PCN# 20230205000

## Resolution of First Article Inspection Issues

### MitySOM-AM62 Modules

**Title:** Resolution of issues encountered on FAI units.

Figure 1 MitySOM-AM62 Pin 21 configuration, Revision -1 Variants

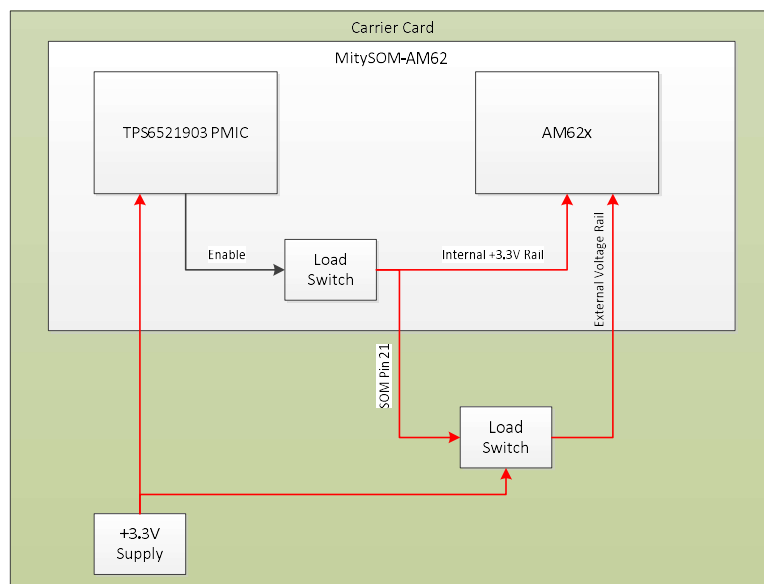
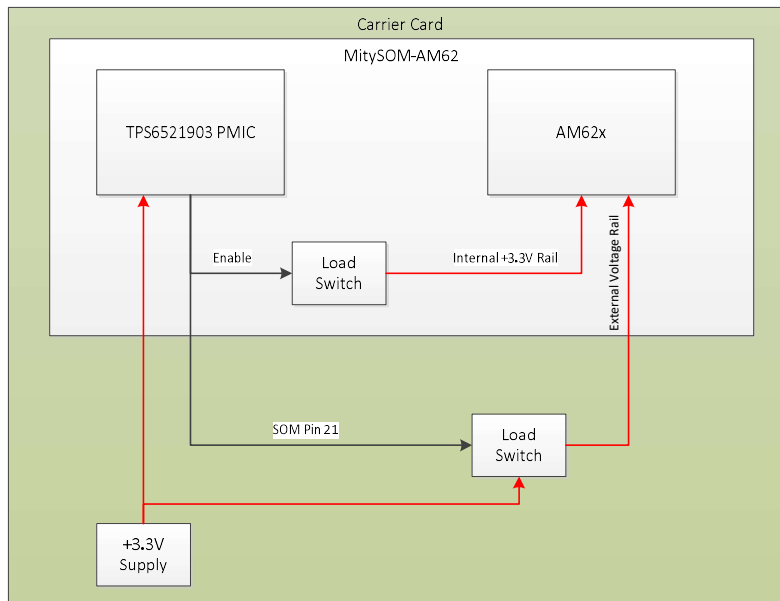
The revision 1 variant of the SOM provides a +3.3V output from an on-board load switch on Pin 21 of the edge connector that was intended to provide a sequenced voltage output or voltage output enable for the carrier cards in order to meet the AM62x processor power rail sequencing requirements. This is shown in Figure 1. The local +3.3V IO output is used on multiple IO rails on the AM62x. The signal presented to the external pin has been changed to be the load switch enable signal instead of the load switch output, as shown in Figure 2.

During module power down testing (via command from the module software), a leakage path was identified from the external +3.3V supply rails passed to one of the AM62x IO supplies back to the local +3.3V IO power domain via the AM62x processor. This leakage would cause the output voltage to be held higher than a typical shutdown voltage threshold, and the result was the external +3.3V load switch circuit (in this case, on the Development Kit board) would not power down as expected. To ensure a proper power down sequence, using the enable signal from the PMIC directly routed to the external power switch ensured proper shutdown.

With this change, it should be possible for the MitySOM-AM62 to properly shut down all external supplies connected to the processor (given the carrier card honors the enable signal presented on Pin 21). However, Pin 21 may no longer be used as a sequenced supply. Any carrier card requiring external +3.3V IO voltages connected to the AM62x bank pins of the MitySOM-AM62 will require an external load switch circuit as shown. See the MitySOM-AM62 development kit schematics for an example circuit to accomplish this.
